2022 Draft Final Blacktail Creek Groundwater Hydraulic Control System Remedial Design Work Plan

RE: Draft Final Blacktail Creek Groundwater Hydraulic Control System (BTC GWHC) Remedial Design Work Plan (RDWP)

**Response to Agency Comments to the
Butte Priority Soils Operable Unit (BPSOU) Draft Blacktail Groundwater Hydraulic Control
System Remedial Design Work Plan**

Date of Comments: September 29, 2022

SITE LOCATION MAP

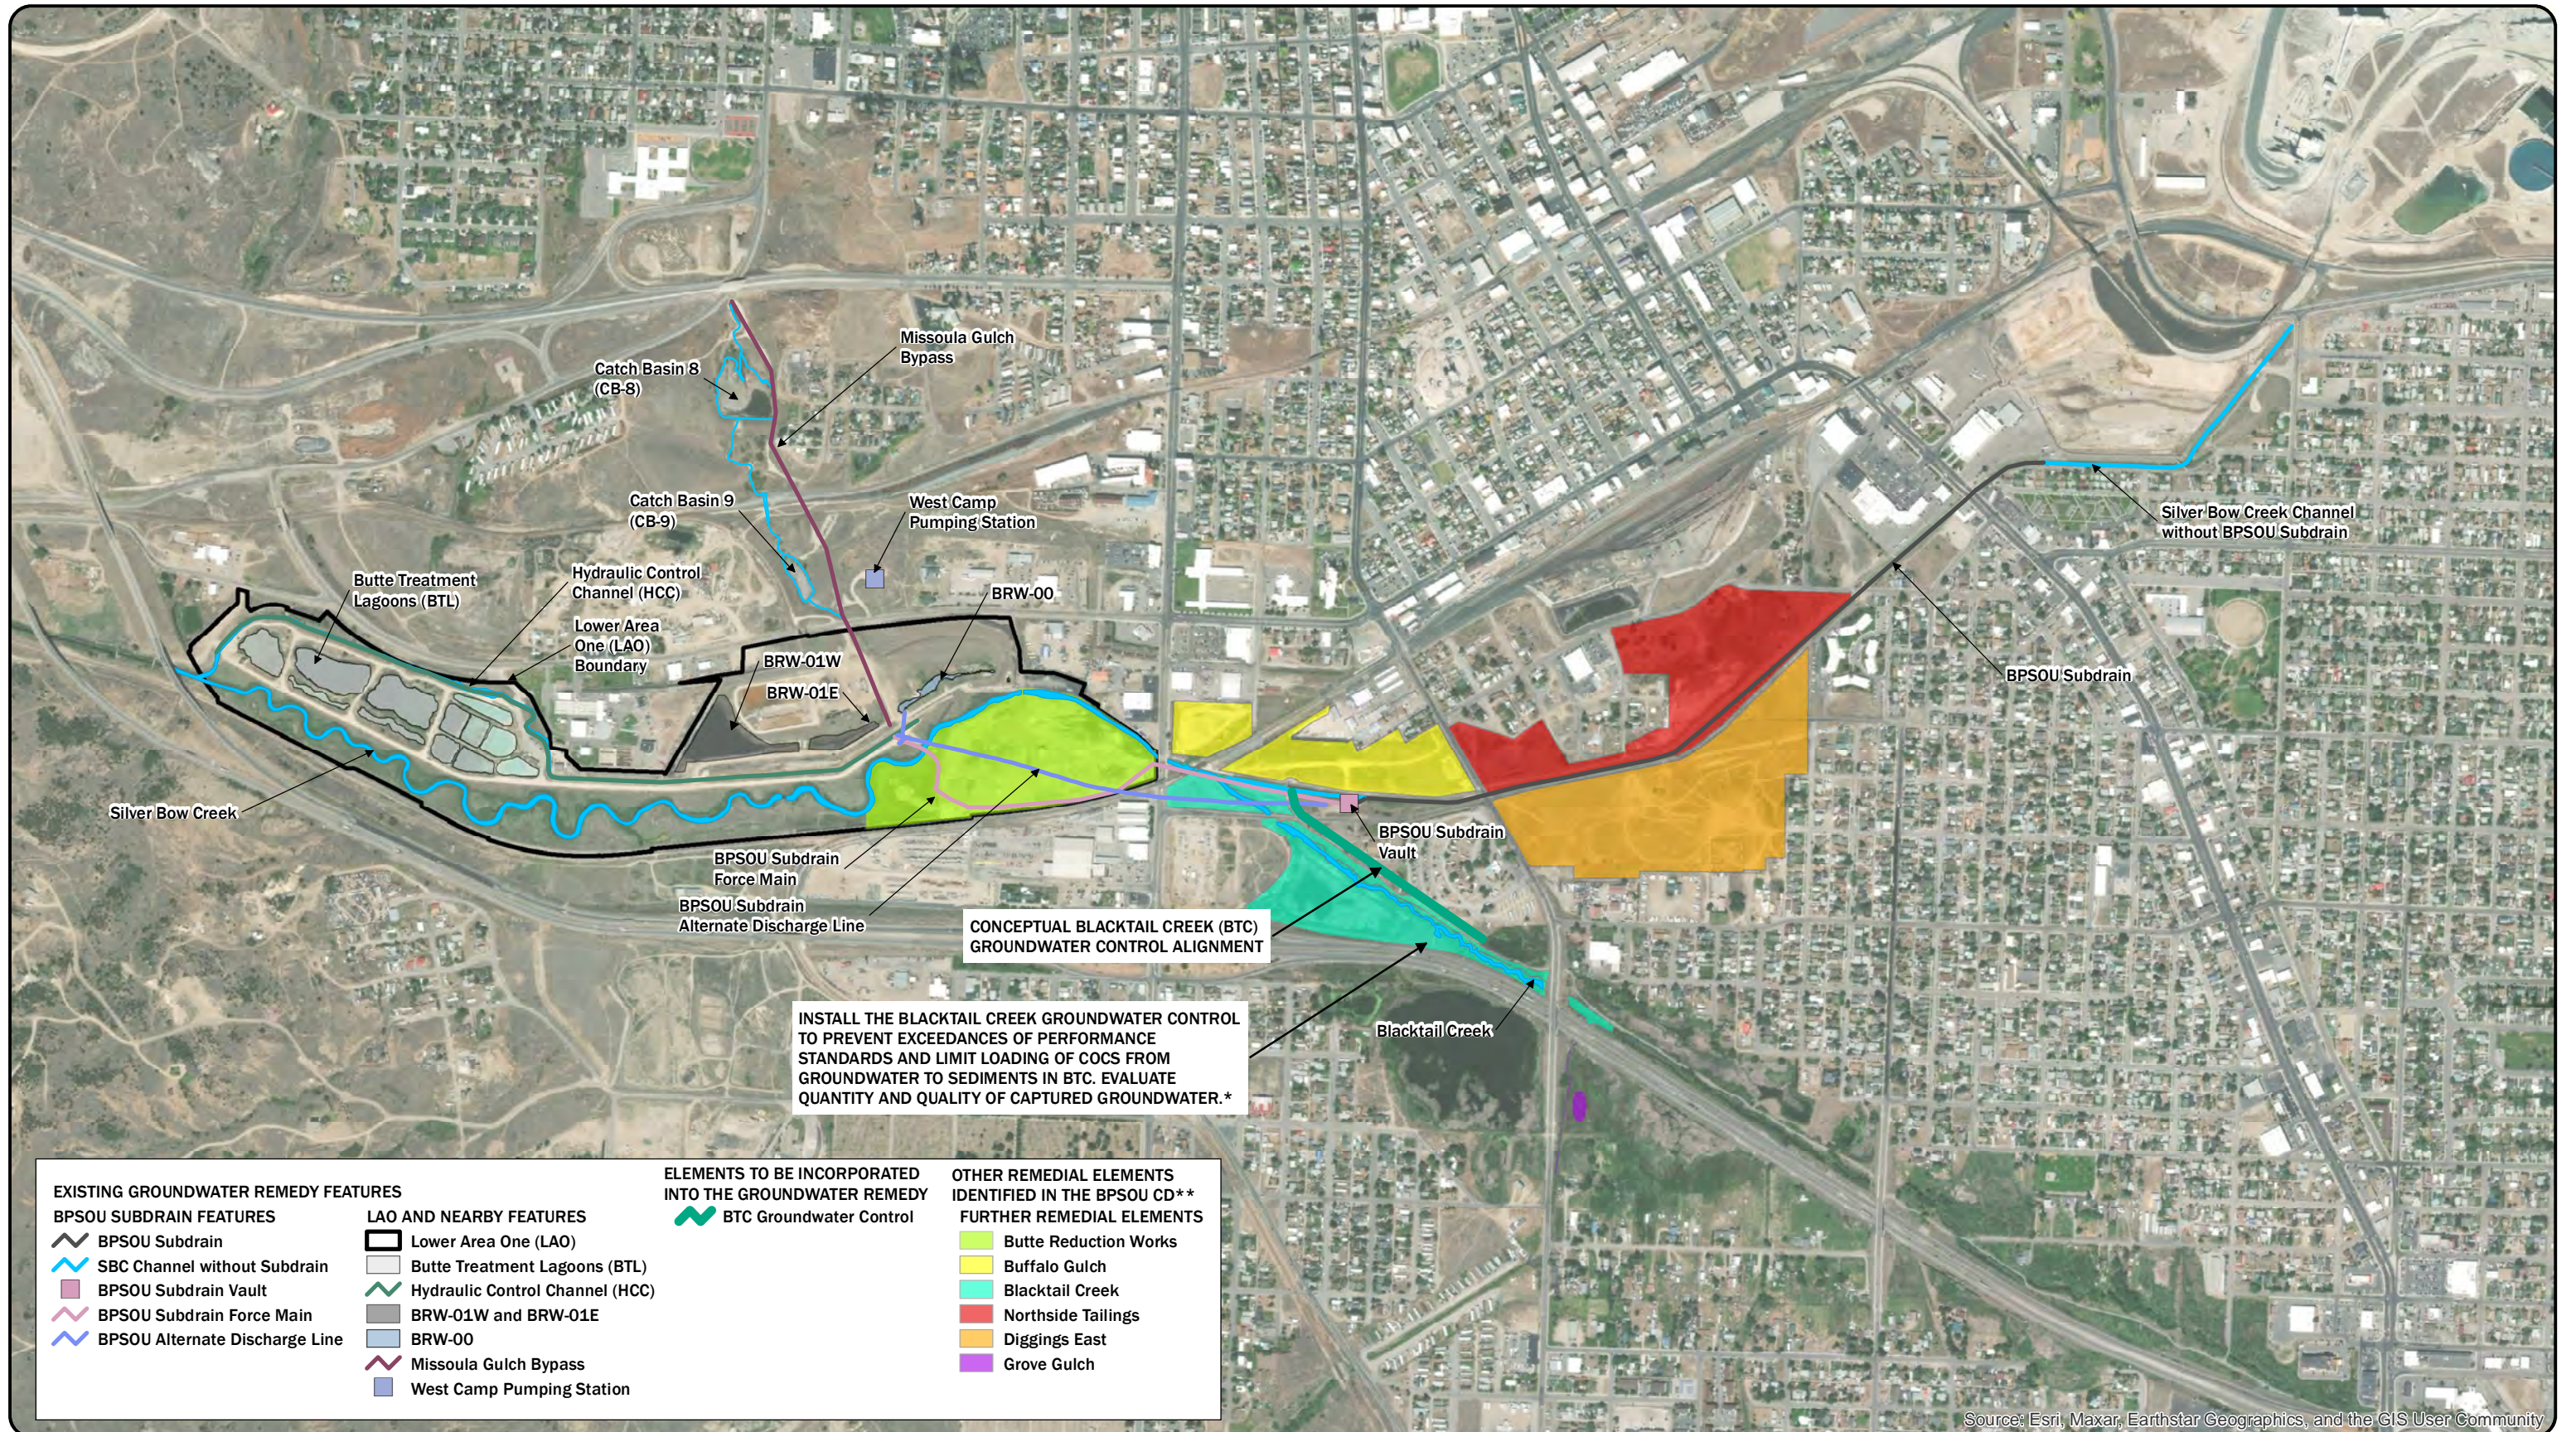
EPA Specific Comment 23a (Figure 1): Site Location Map. Compared to other RDWPs, the projection/zone, datum, units, and source differ from figure to figure. Is there a way to be consistent between figures, both in what datums are listed and in naming convention?

EPA Specific Comment 23b (Figure 1): The state location inset map does not provide great value to the figure, as it does not do a good job of specifying the project location. Please consider highlighting Butte in the inset map to help clarify the project location.

EPA Specific Comment 23c (Figure 1): Please define TI Zone in Acronyms list.

Atlantic Richfield Company Response: All maps have been updated with consistent projection/zone, datum, units, and source.

Atlantic Richfield Company Response: Butte is now highlighted in the inset map.

Atlantic Richfield Company Response: "TI Zone" has been added to Acronyms list as requested.

SITE OVERVIEW AND
 BLACKTAIL CREEK GROUNDWATER
 CONTROL SYSTEM CONCEPTUAL
 REMEDIAL DESIGN

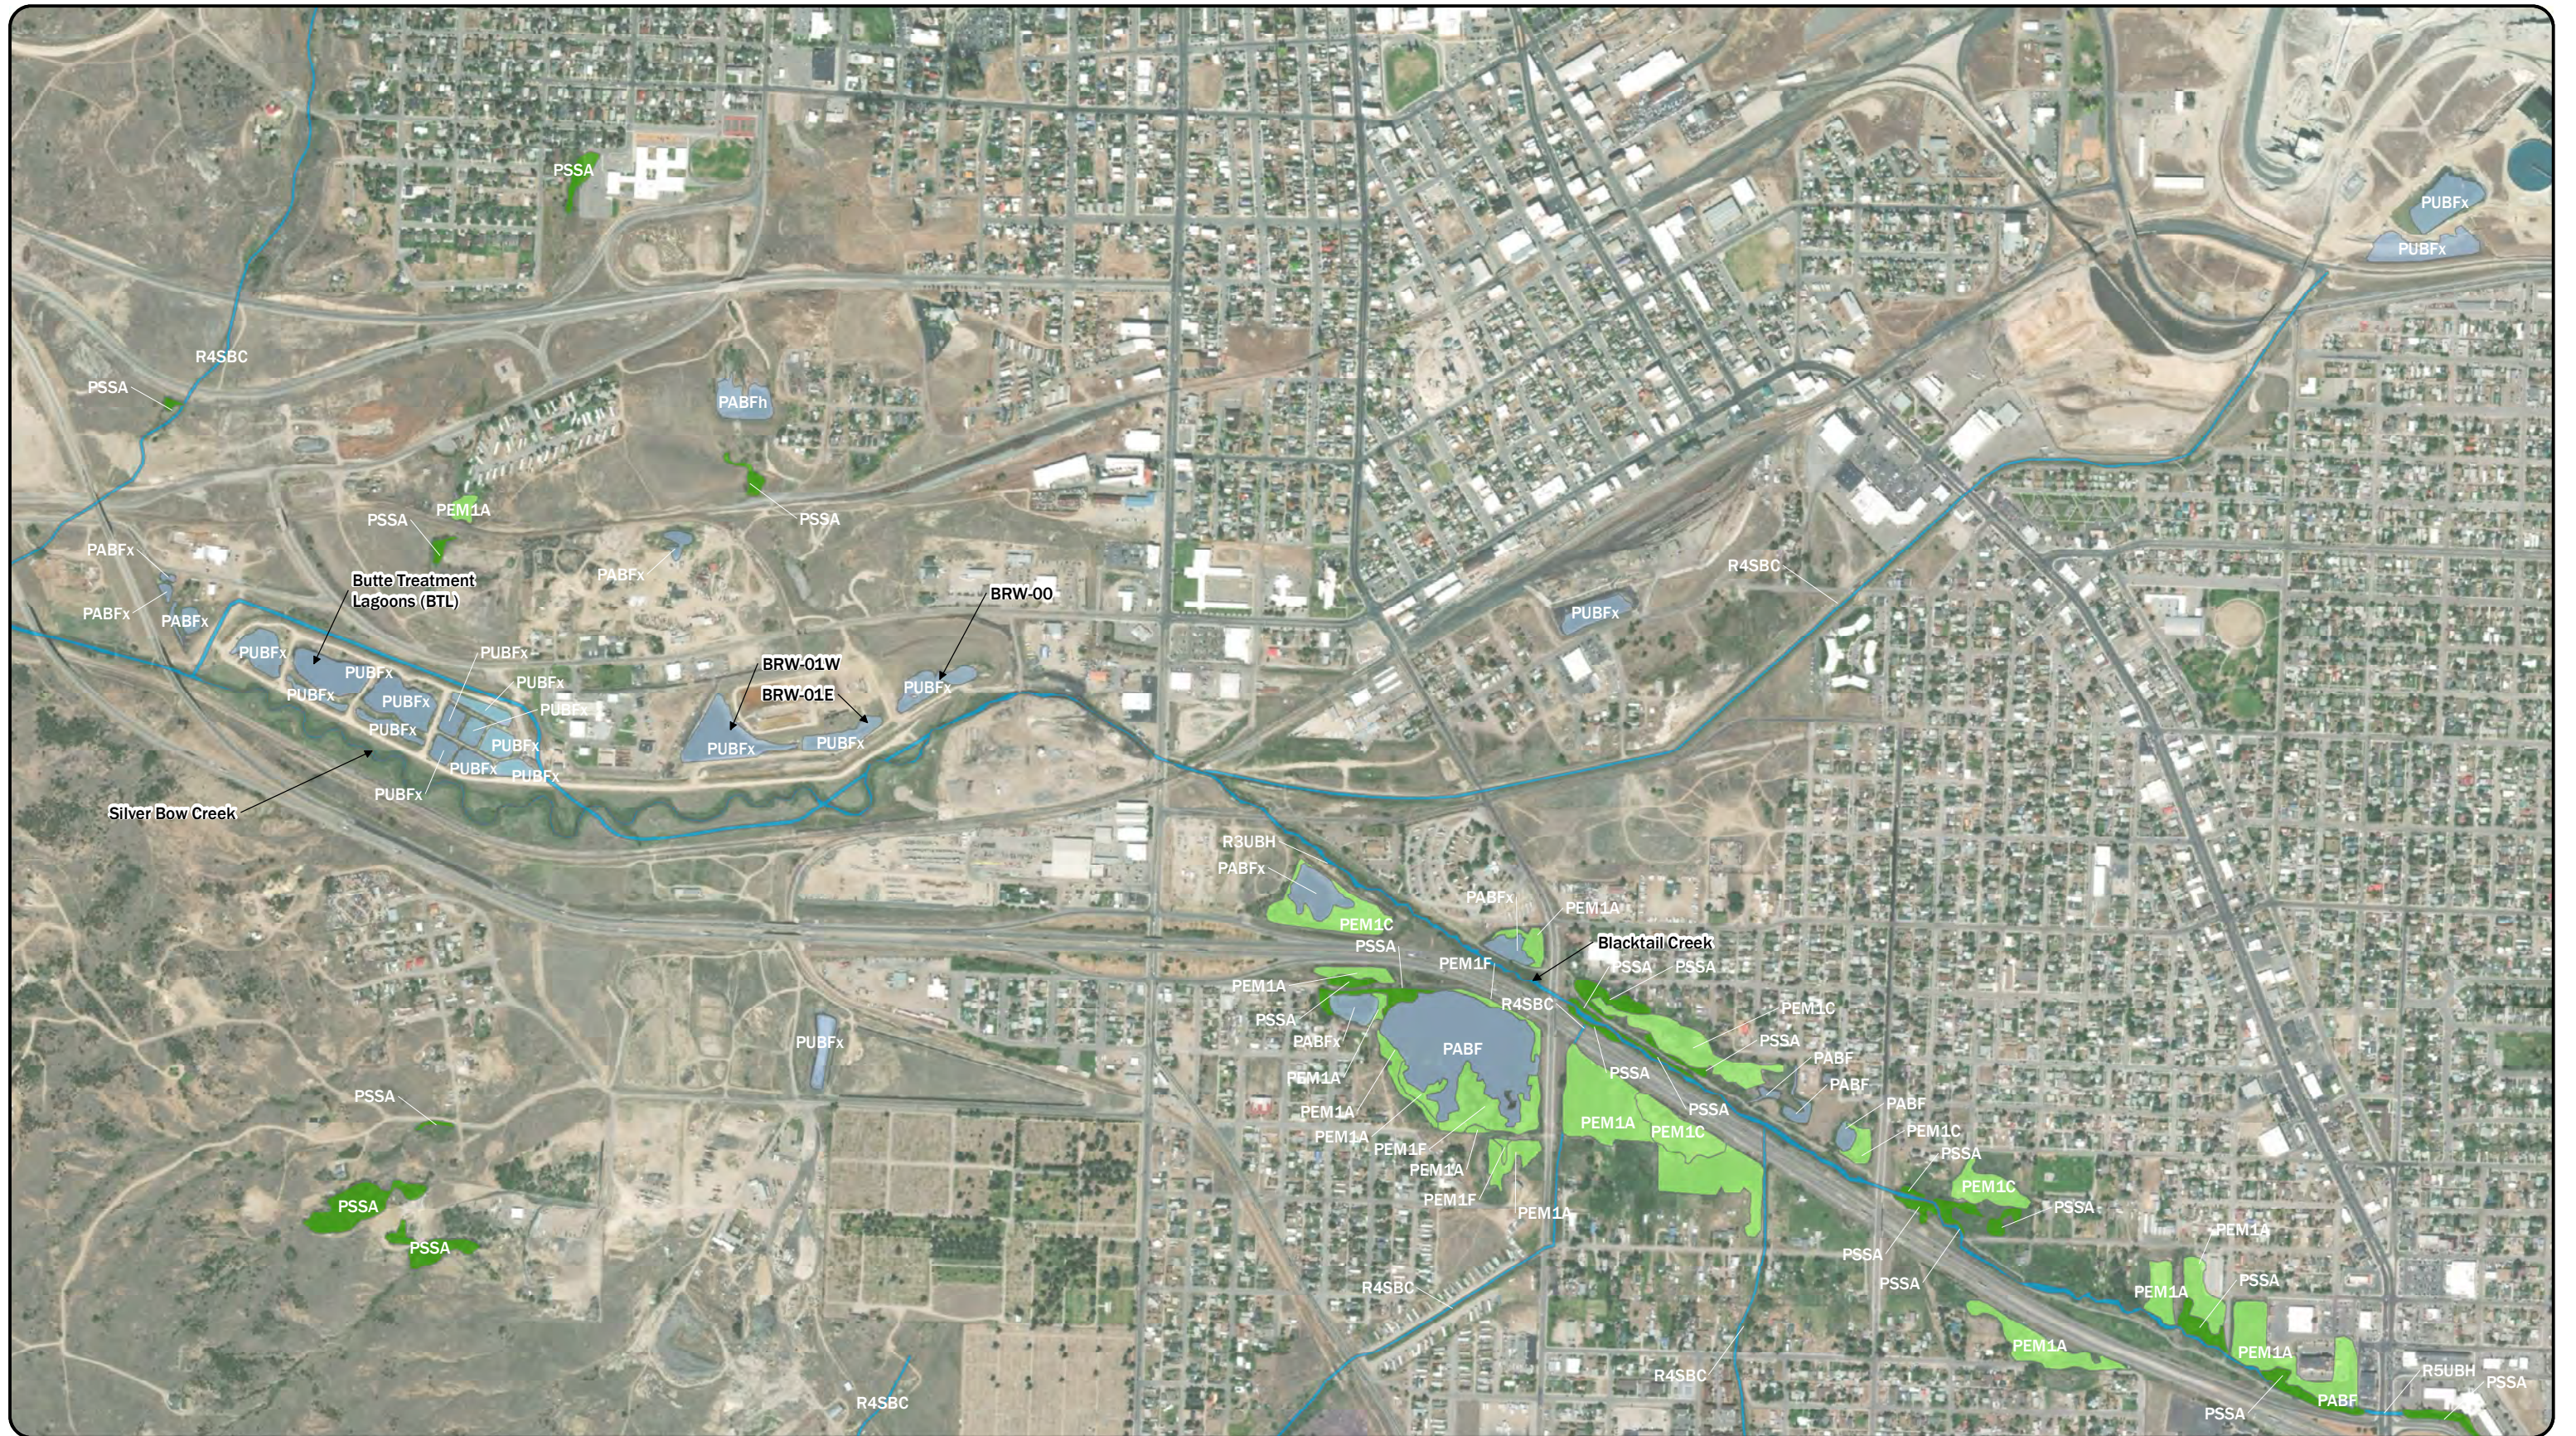
EPA Specific Comment 24 (Figure 2): Site Overview and Blacktail Creek GHCS Conceptual Remedial Design. There are no projection/zone, datum, units, or source listed. Please be consistent with *Figure 1*.

Atlantic Richfield Company Response: All maps have been updated with consistent projection/zone, datum, units, and source.

Figure 4. Project Organizational Chart

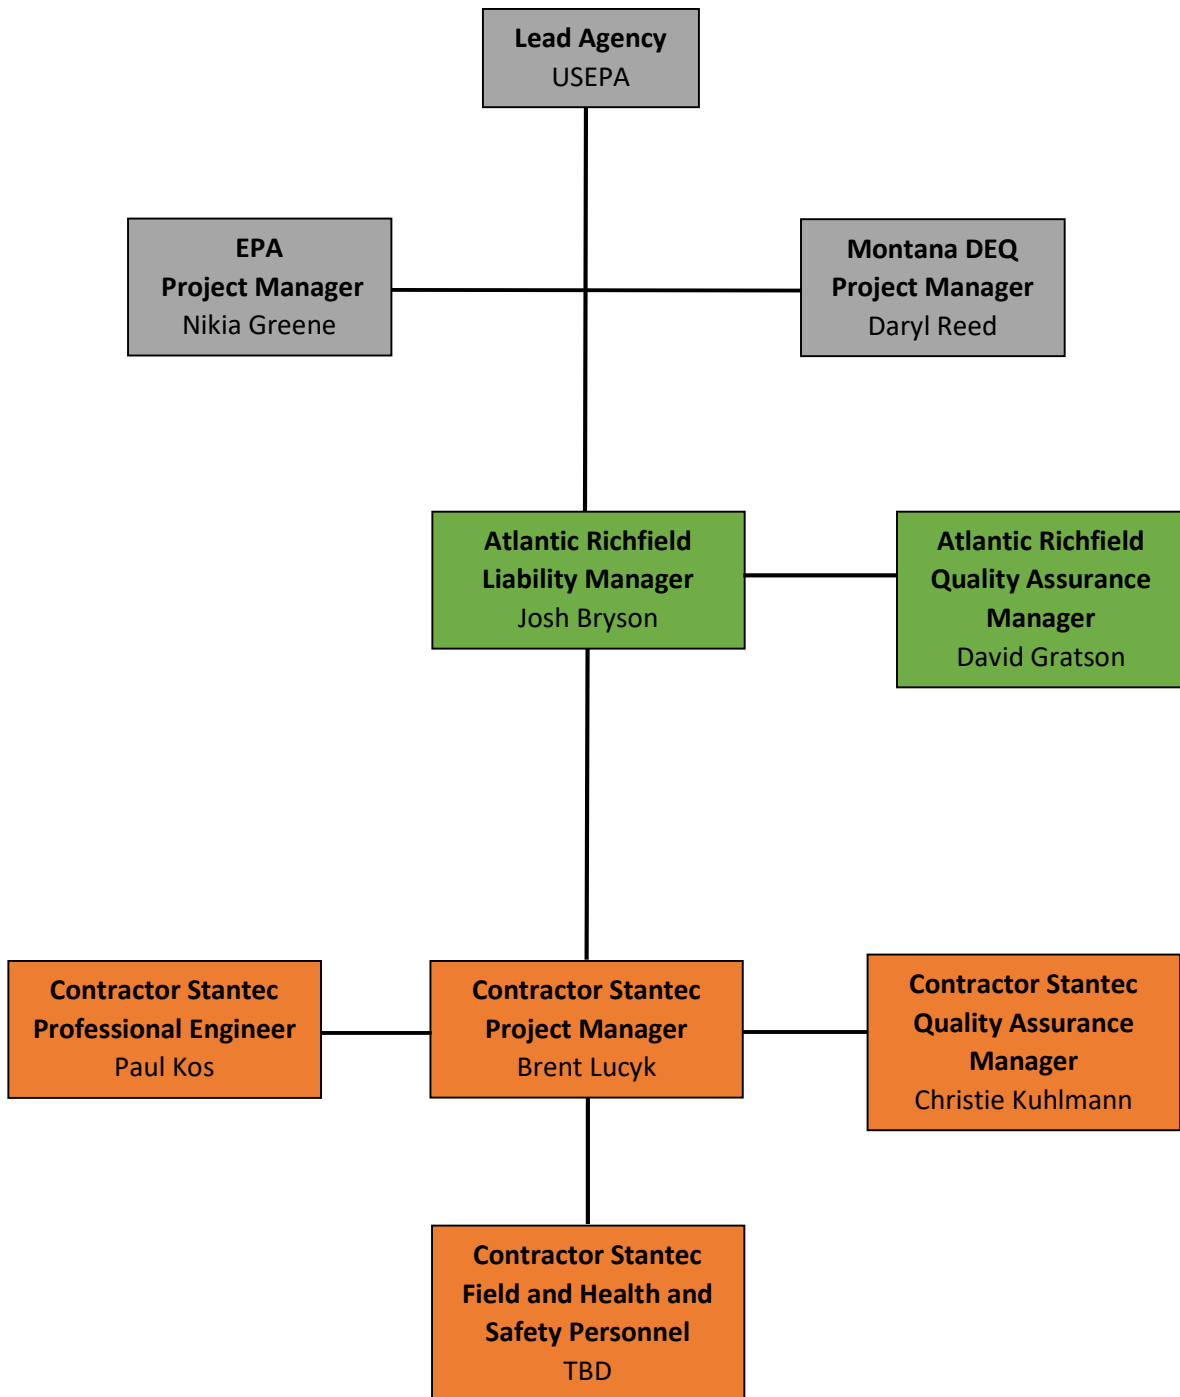
EPA Specific Comment 11 (Section 4.0 Project Organization): Please consider adding a hierarchy chart (hierarchy diagram) to portray the key organizations involved with developing/implementing the RD. This would help the reader to quickly visualize the top-down modular breakdown of the entire system.

EPA Specific Comment 15 (Section 4.2 Key Personnel): As with the comment above, please consider adding a hierarchy chart (hierarchy diagram) to portray the key personnel involved based on their roles and responsibilities. This would help the reader to quickly visualize the top-down modular breakdown of the entire system.

Atlantic Richfield Company Response: A project organizational chart with key personnel’s roles and responsibilities has been included as Figure 4.

Atlantic Richfield Company Response: A project organizational chart with key personnel’s roles and responsibilities has been included as Figure 4.
